Narelle and Paul van den Bos' objection to SIMTA Stage 2

#### Construction Traffic Impact Statement

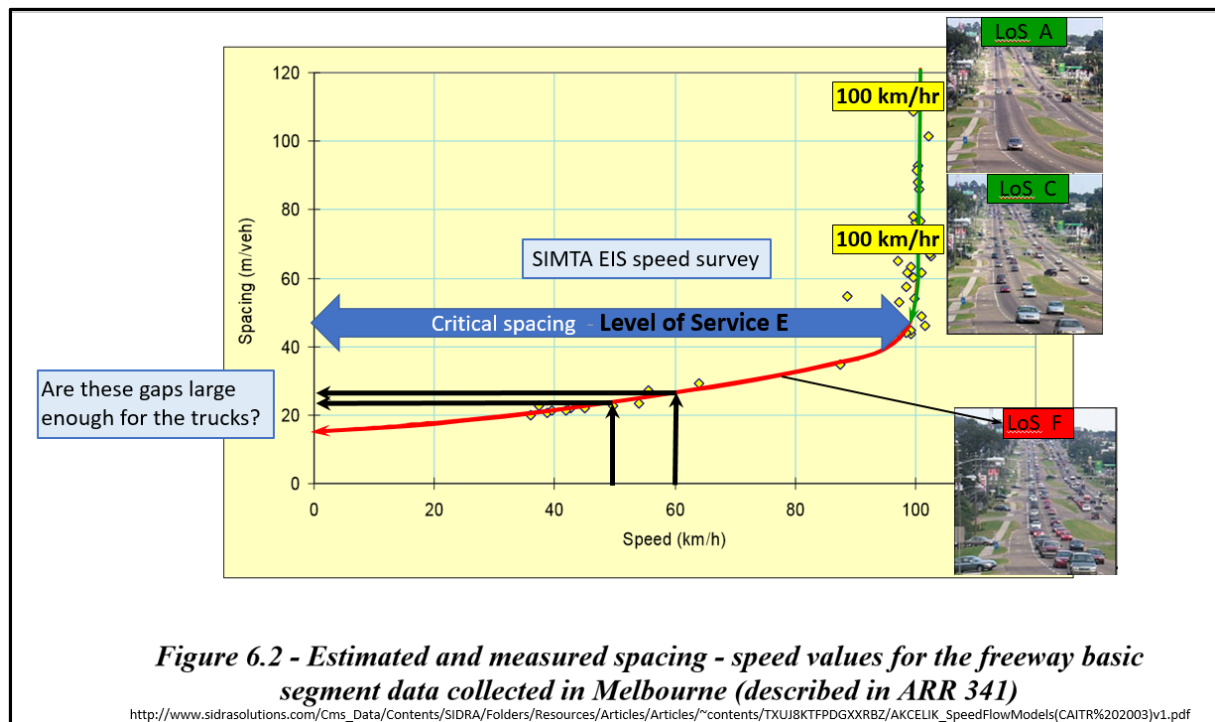
- Only covers the travel details while traffic is on Moorebank Av
- the report does not cover the remaining components of the journeys:
  - how on the forward journey, the traffic will reach Moorebank Avenue from their origins, nor how this traffic will return to after leaving Moorebank Av

Further network operational analysis indicated ten intersection-related issues within the “core” area. While some of these issues do not necessarily reflect an overcapacity situation for the entire intersection, any further increase on demand from both future background and SIMTA traffic at these intersections should be investigated thoroughly. The identified intersection operational issues are summarised in Figure 3-7.
